**Request for Proposals 2024-045**

**Beaverdam Creek Richardson Creek Debris Removal**

**ADDENDUM No. 1**

**ISSUE DATE: December 12, 2023**

**Attachment No.1:** Access Points

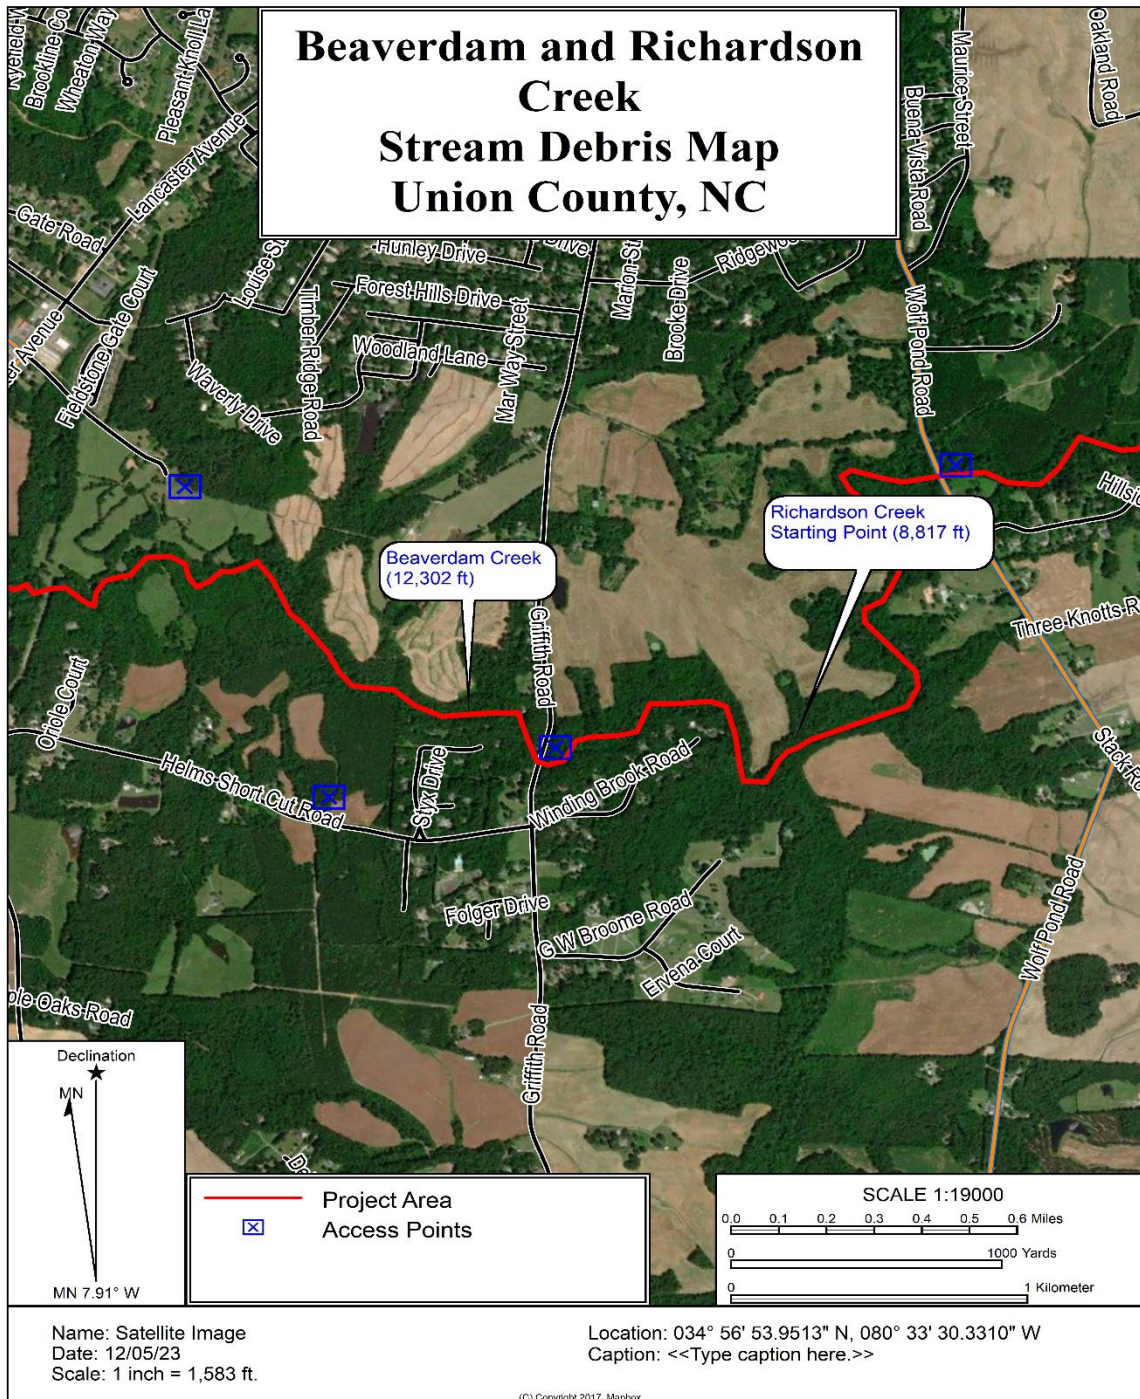
1. **Section 10 Appendix D – Maps of The Designated Areas:** At the end of this section Add “Attachment No.1 Access Points”.
2. **Section 10 Appendix D – Maps of The Designated Areas:** At the end of this section Add “Attachment No.2 Flood Plain”.

1. **Question:** I Did not make the pre-bid meeting this morning for this project. I would like the location information to visit the site at a later date.

**Answer:** Please see below in Attachment No 1.

Floodplain Map

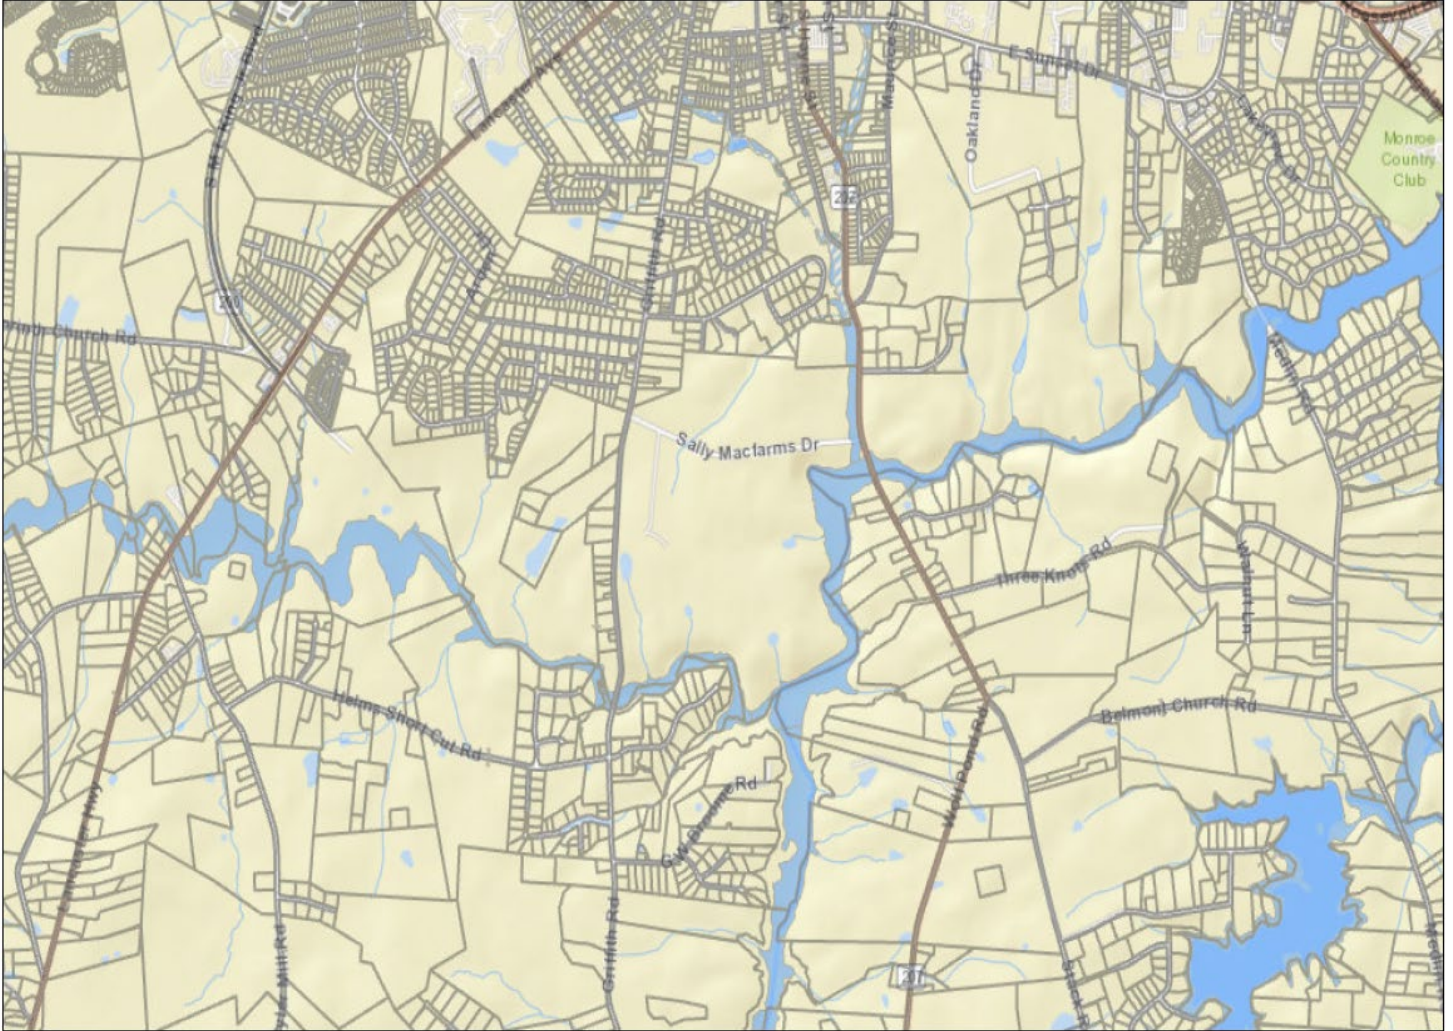
2. **Question:**, Can you please provide a map of the floodplain.

3. **Question:** Should all debris be removed from the floodplain in accordance with the floodplain map.

**Answer:** Please see below in Attachment No 2.

**Answer:** All debris needs to be removed from the floodplain.
